Technical Note No. 210

Discussion on the Requirement Analysis and
Preliminary Design of the New AGS Controls

December 6, 1984

Fig. 1. LOGICAL REPRESENTATION OF SYSTEM ARCHITECTURE.

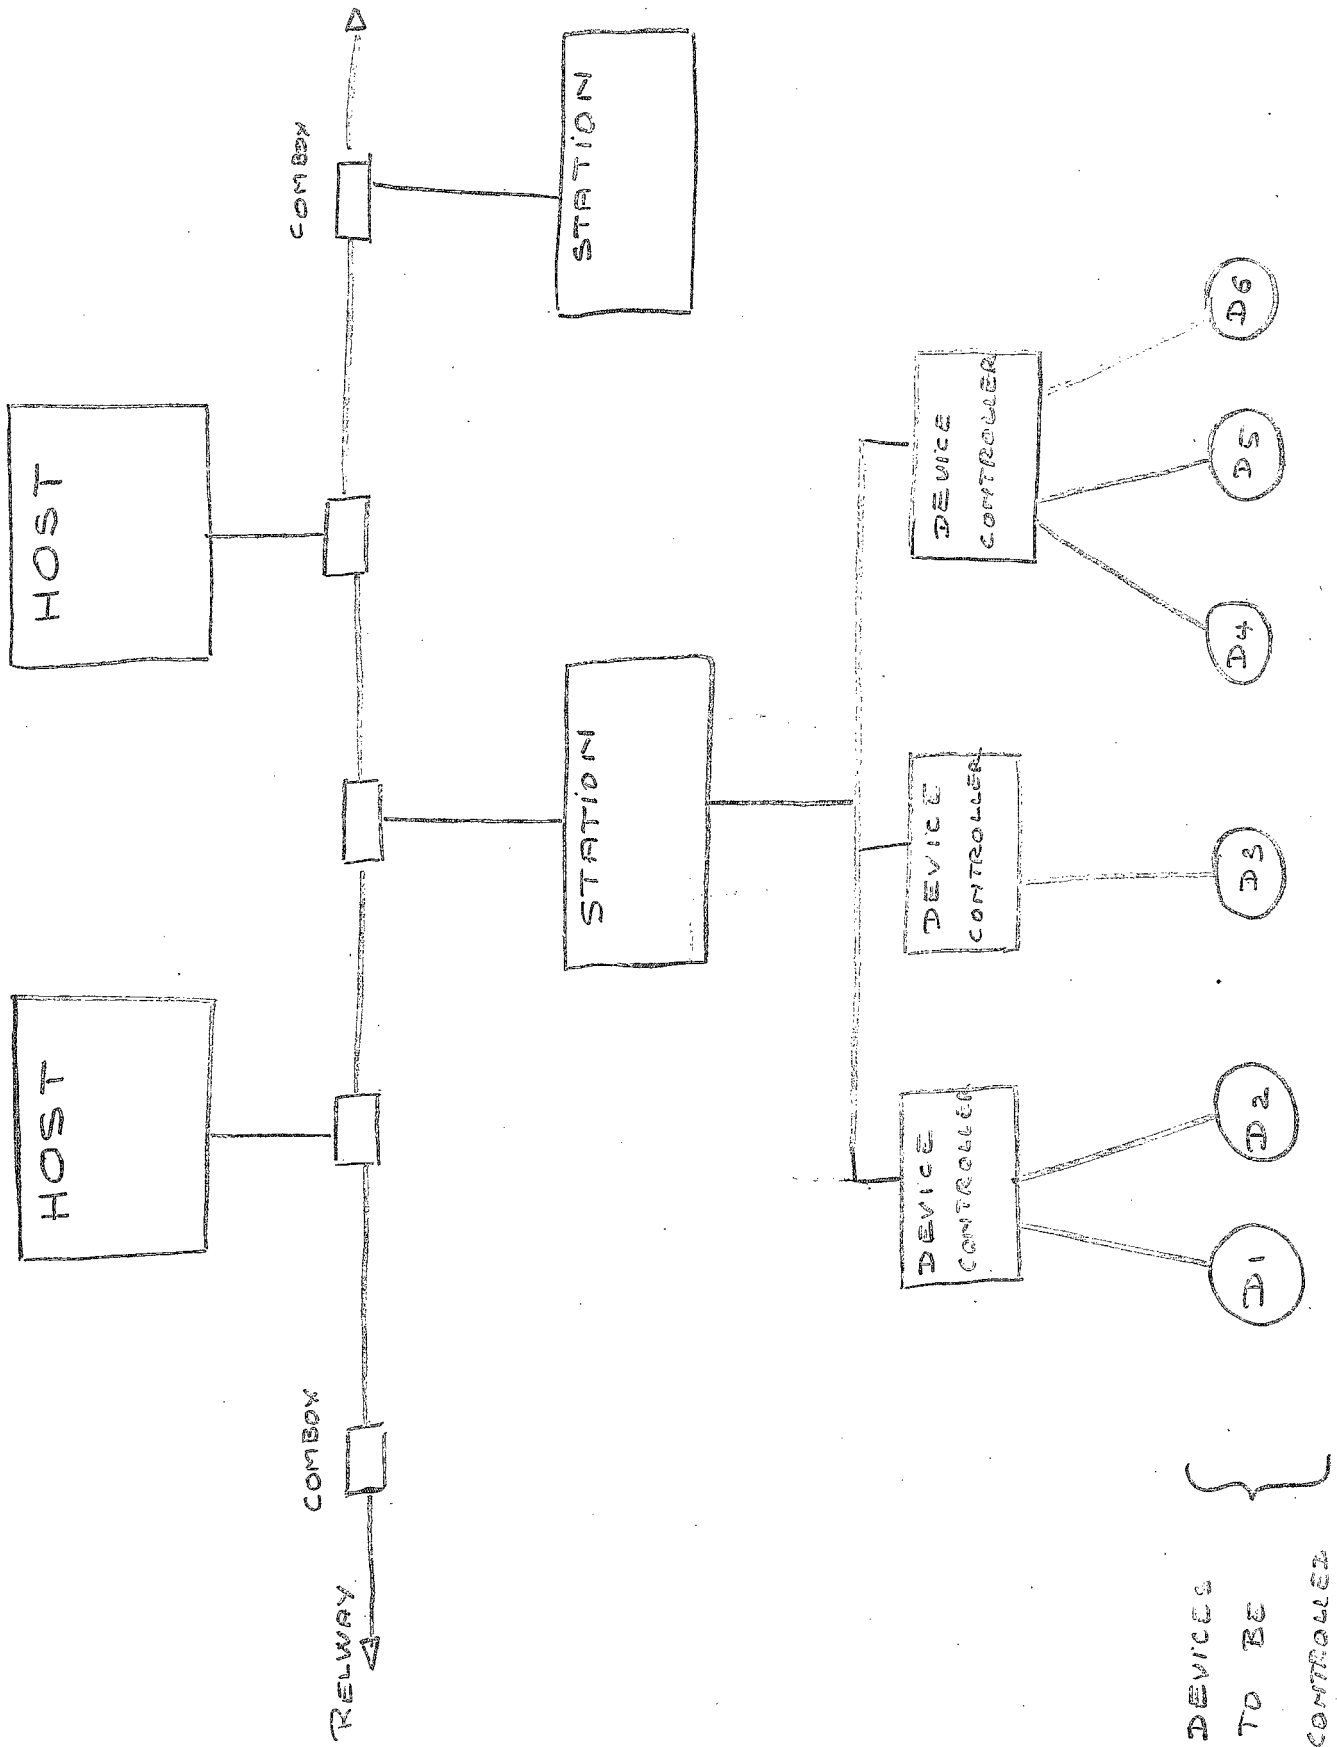
The system architecture hardware is defined in detail and so is the communication software. (Communications protocol between host/station/device controller.)

The functionality of the low level software, i.e., at the level of device controller and station is defined. The concept of logical devices, the basic building block of the control software, provides flexibility for later extension to PPM.

The functionality of the high level module, i.e., in the host needs to be studied further. In general, it deals with device specific functions as conversion from physical units into counts including limit checks: this would be more efficiently performed in the device controller. This would enhance the reliability of the system since errors may appear during the transmission of "count values" between the host and the device controller. An additional advantage is that data in physical units would be available to the device or controls specialist working locally in stand-alone (i.e., independent of the network). Local display of device controller data would also be available in physical units (e.g., chapter on instrumentation).

Fig 2.

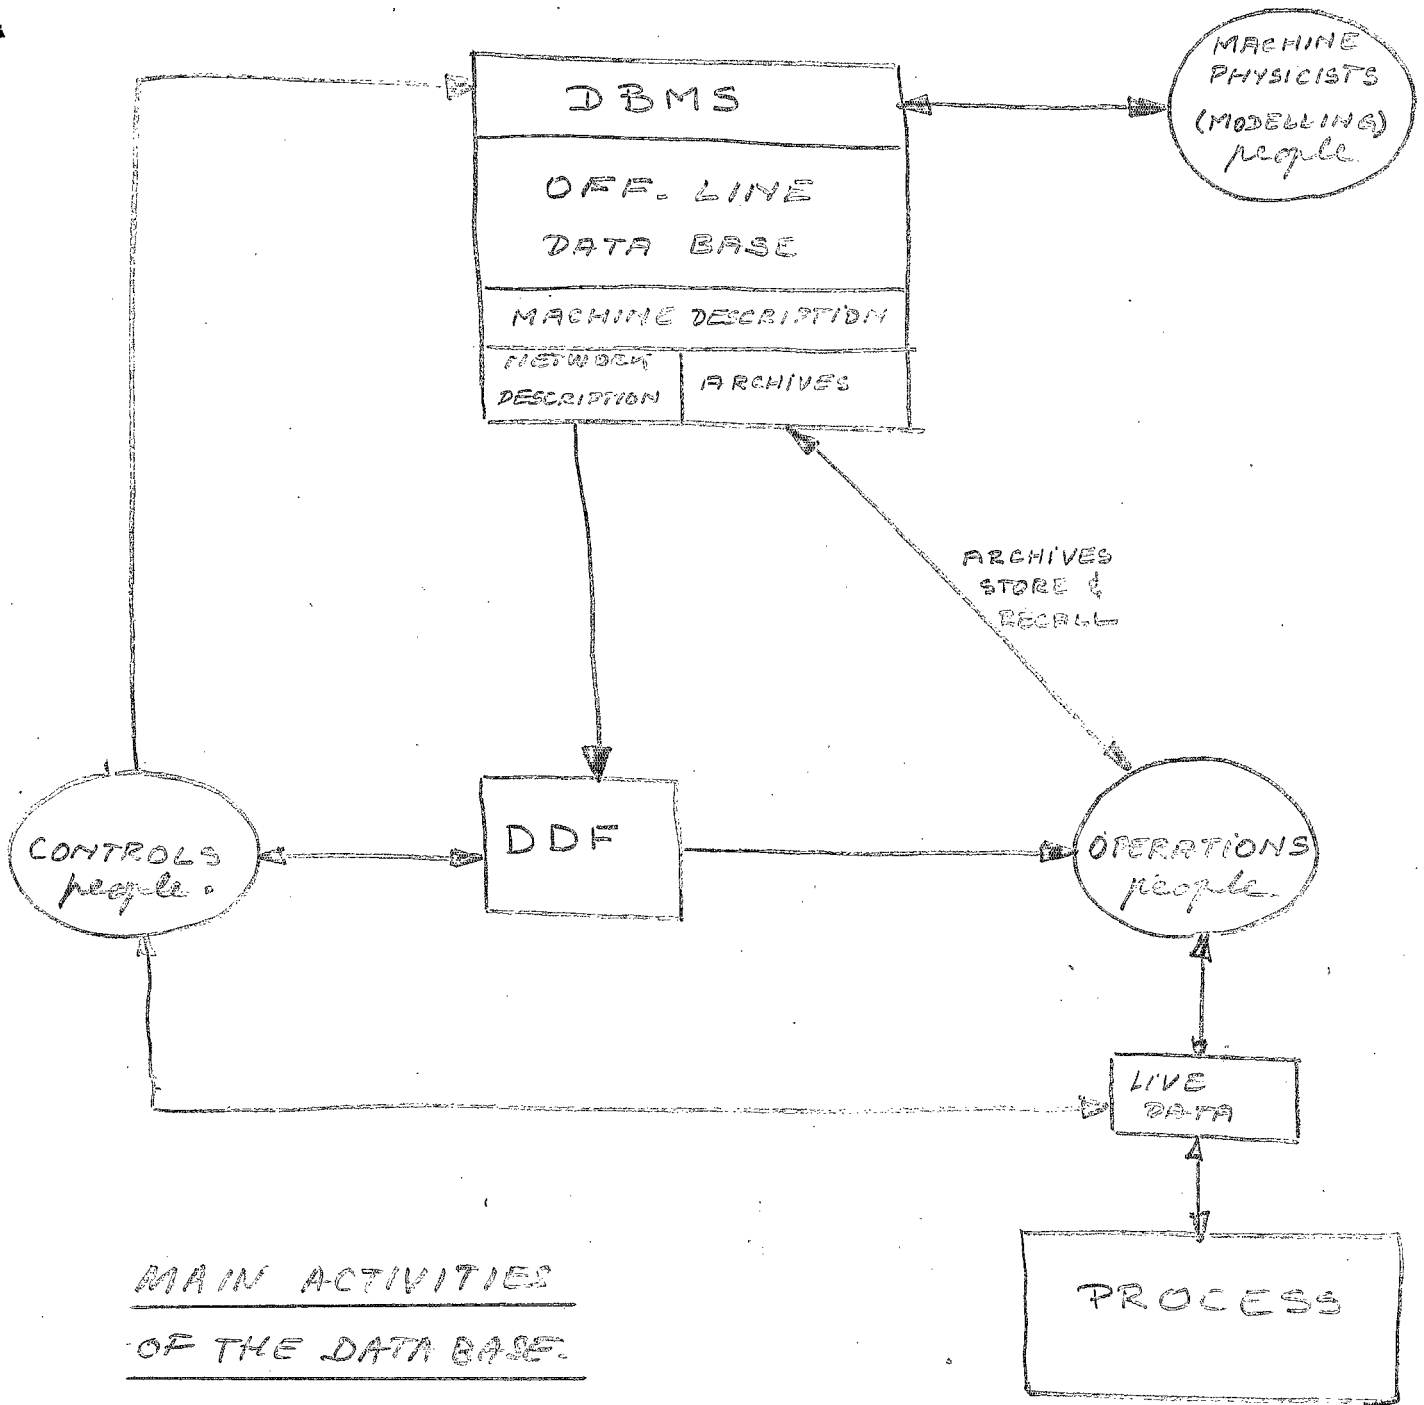
There seems to be general agreement that for the purpose of on-line controls only a simple data base [Data Description File (DDF)] consisting of flat files may be sufficient. For on-line controls, speed of access is of prime importance.

Other applications of a more clerical type (e.g., magnet characteristics, process archives) require more flexibility as can be provided by commercially available type data bases. So, in general, one agrees that a compound of simple data base, a DDF, and commercial one should be able to cope with "all" problems.

There are still some discussions as to whether one could start from a simple homemade data base and later add a commercial one from which the simple on-line data base could be generated. This strategy is a pragmatic one which copes with the rather tight HITL schedule. Moreover it ensures the availability of fast access to data as required by most control applications. It was suggested to invest some limited effort investigating commercial data bases available on the site to ensure ourselves that they can generate the requested DDF.

For the sake of completeness, a formal document should be produced giving the user requirements and specification for such data bases.

Fig. 3. Limit of Responsibilities

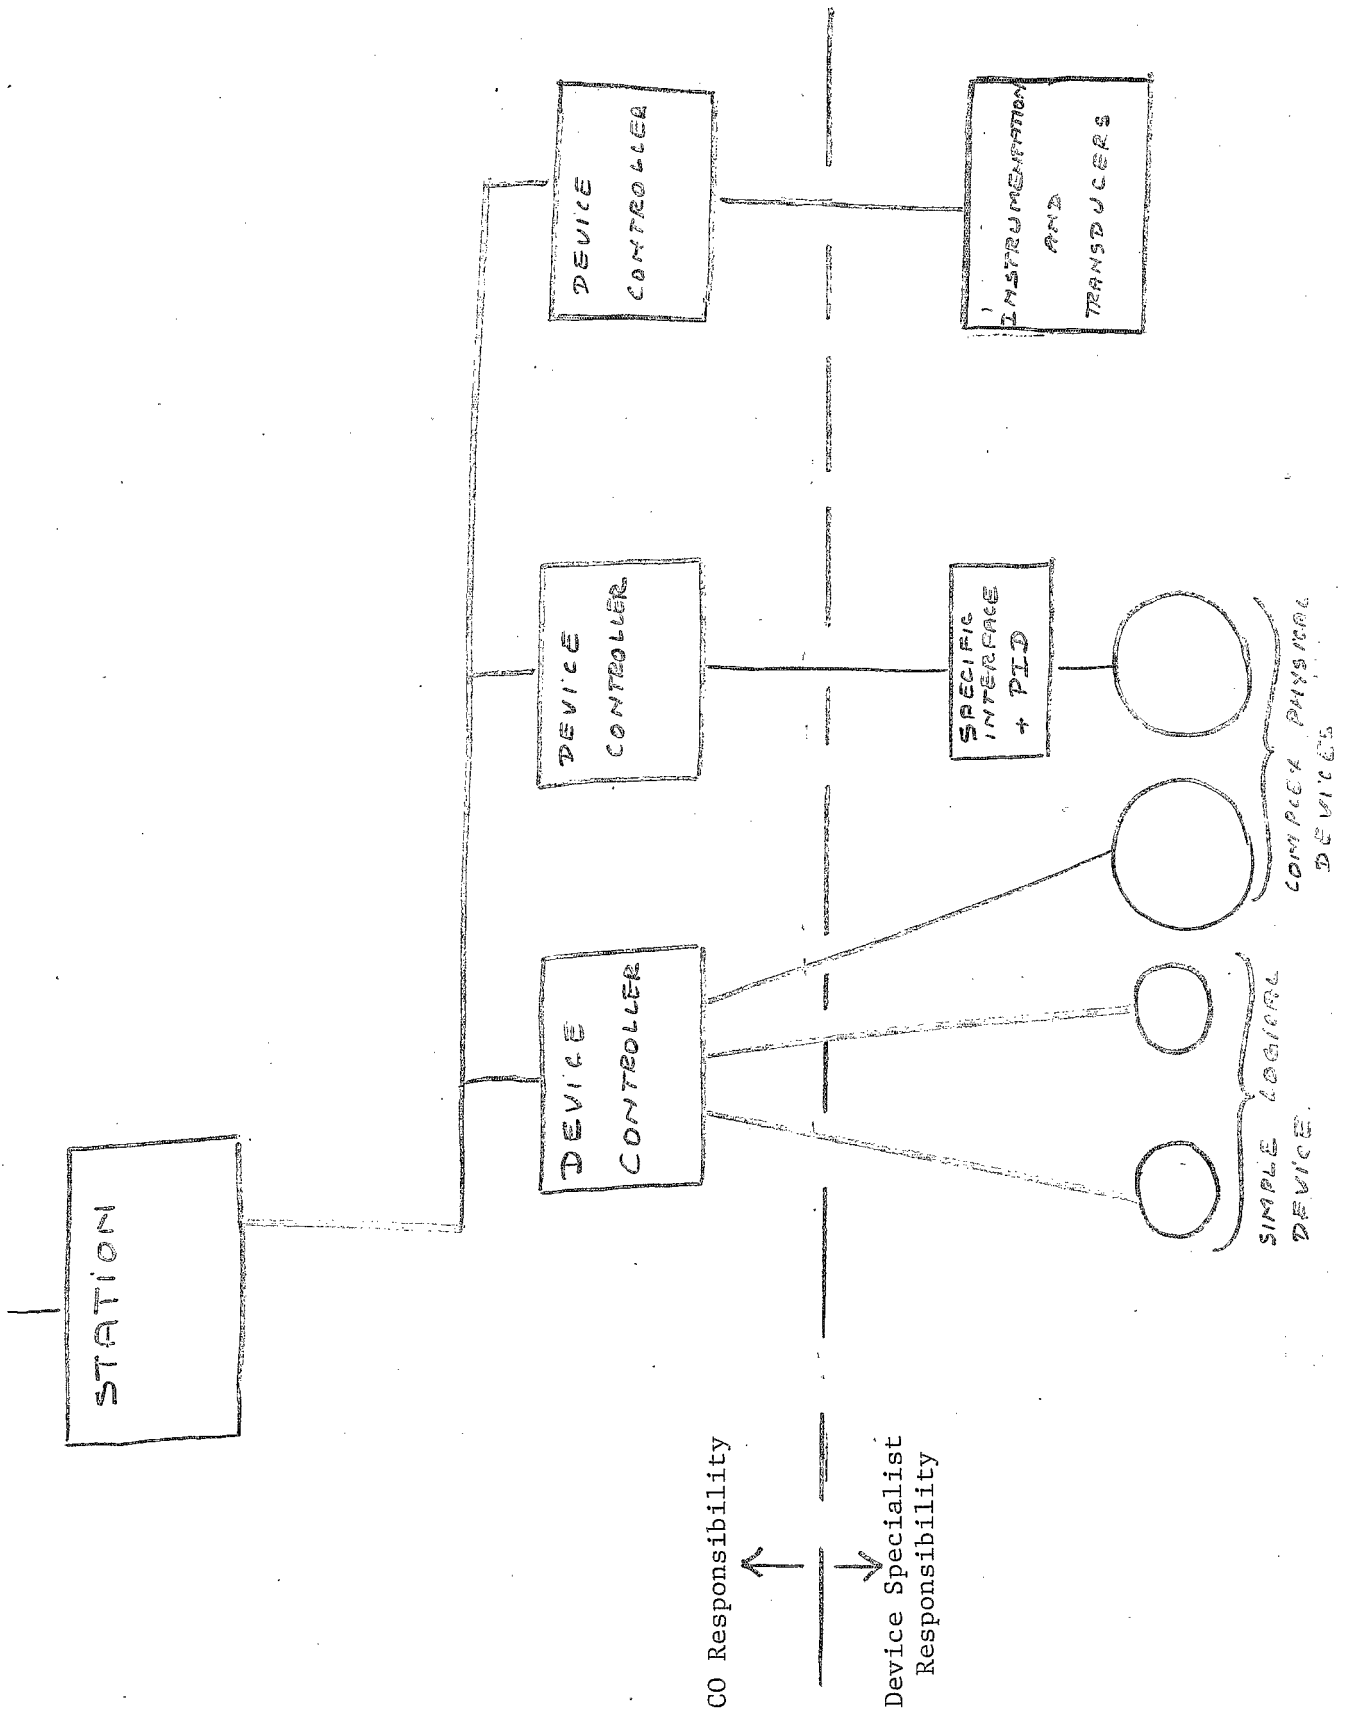
5. Control systems involve contributions of many people belonging to different administrative groups. It is therefore of paramount importance to have clearly defined responsibilities. Mixing responsibilities as seems to be the case in the device controller, an item which needs to be most reliable, can only lead to reduced performance, reliability, and demotivation of the implementers. We would therefore suggest that the CO keeps the entire responsibility in the device controller. If device specialists have to develop any device specific algorithms (e.g., PID loops) they should be implemented within the device itself. (Figure 3.)
